AEROPRAKT

INFORMATION BULLETIN

REPLACEMENT OF THE DOOR AIR SCOOPS OF A-22 AIRCRAFT

IB A-22-07

Fig. 1

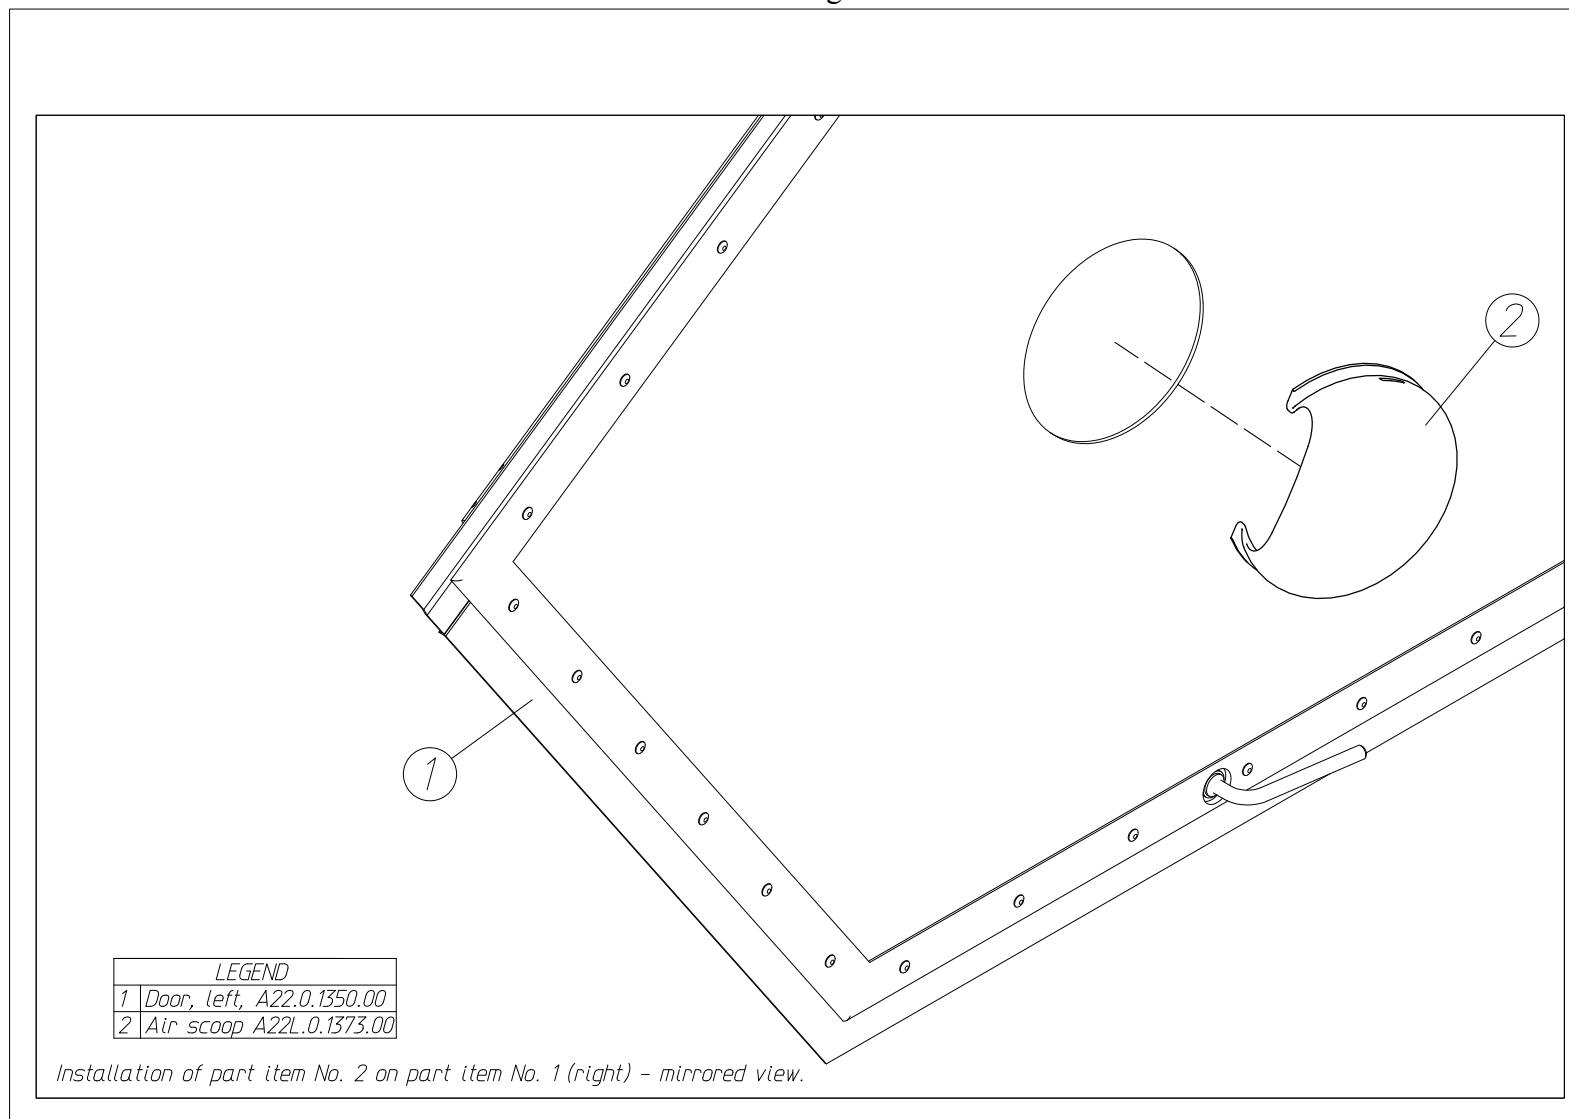
The air scoop has the shape of a lens which focuses the direct sun light and causes melting of the seat cushions and floor rugs.

- 1) Remove the old air scoop.
- 2) Squeeze the new air scoop (2) by hand and install it in the place of the old one.
- 3) Install the scoop handle (3).

◆ **NOTE:** The air scoop must be installed from outside and the scoop handle – from inside.

▲ **WARNING:** In cloudless weather the sun rays, passing through the air scoop, can melt the material of the seat cushions and floor rugs. In the new air scoops this effect is excluded due to the uniform glass thickness over the surface of the air scoop.
